SERVICE BULLETIN No.1175

COACH BUS MODEL	: T2100 and C2000 Series
BULLETIN TYPE	: Service Information
MANUAL & SECTION	: Maintenance Manual: Chapter 12 – Maintenance schedule and appendices
DATE	: March 31, 2006
SUBJECT	: New service requirements for Detroit Diesel Series 60 engines featuring exhaust gas re-circulation (EGR)
TERMS & CONDITIONS	: No claims will be accepted with reference to this Bulletin.

**Figure 1: DD 60
Series engine with
EGR (Exhaust Gas
Recirculation)**

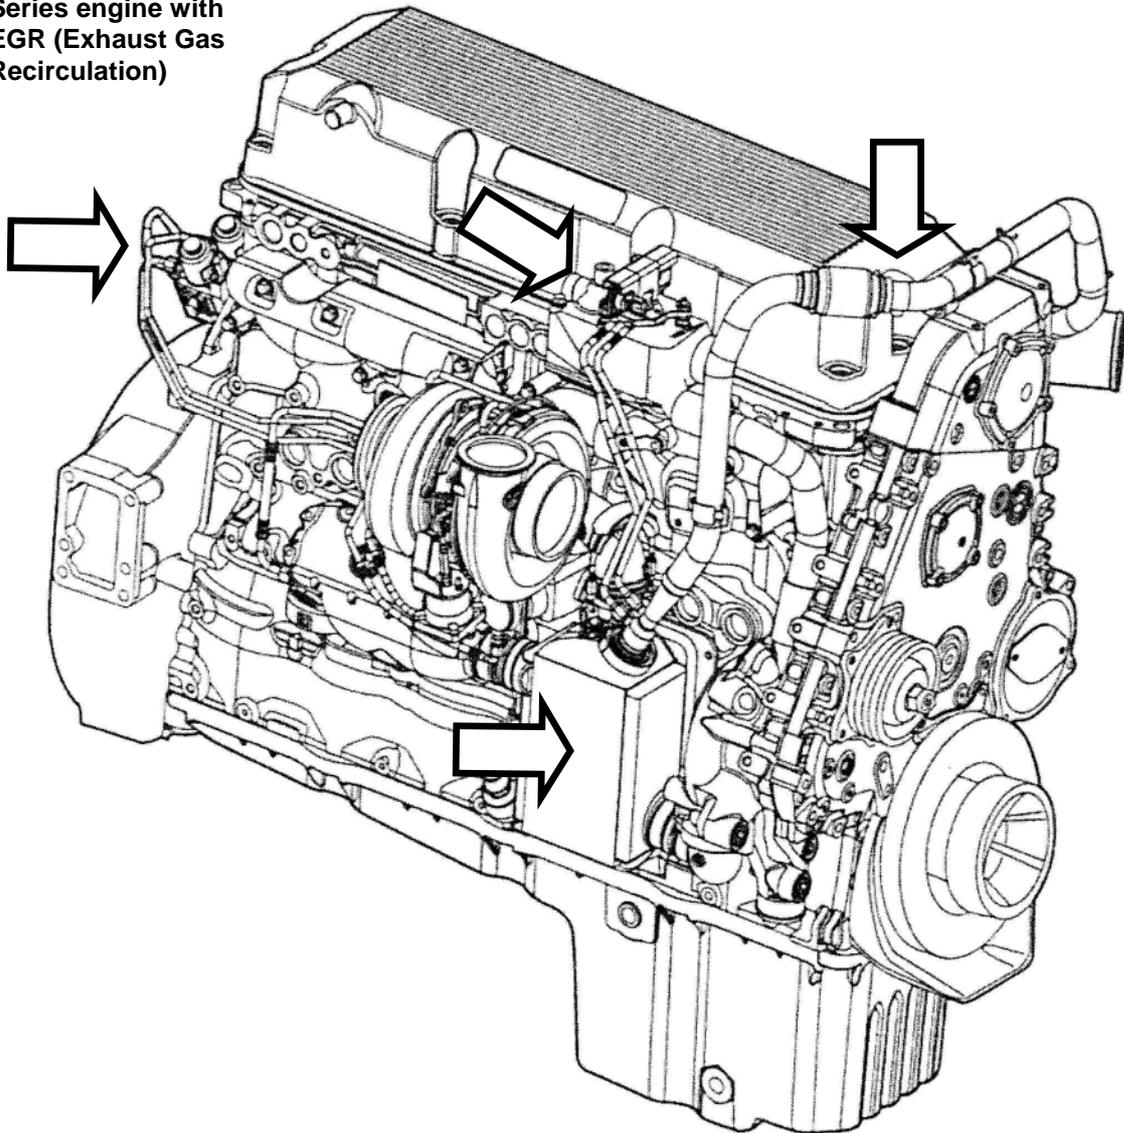
The service information subject of this Bulletin is applicable to Van Hool units equipped with Detroit Diesel 60 Series, model 6067MK2E, and model 6067MV2E engines (see Figure 1, overleaf).

1. New stringent exhaust emission standards have been implemented for Series 60 on-highway engines. To accommodate the higher soot levels that result from the engine meeting the more stringent emission standards, a new lubricating oil formulation has been introduced.
2. The lubricating oil specification for engine models 6067MK2E and 6067MV2E is partly outlined below and is required for engines produced to the new, more stringent emission standards.

3. The new CI-4 classification has been formulated to provide improved dispersency, oxidation control and wear protection. The new formulation replaces the previous CH-4 formulation and can be used in all Detroit Diesel four-stroke engines. Additional information is provided by DDC's Lubricating Oil, Fuel and Filters Bulletin #7SE270.

CAUTION: 6067MK2E and 6067MV2E model engines may erroneously have been labeled near the filler cap with the old API CH-4 reference. Disregard this information.
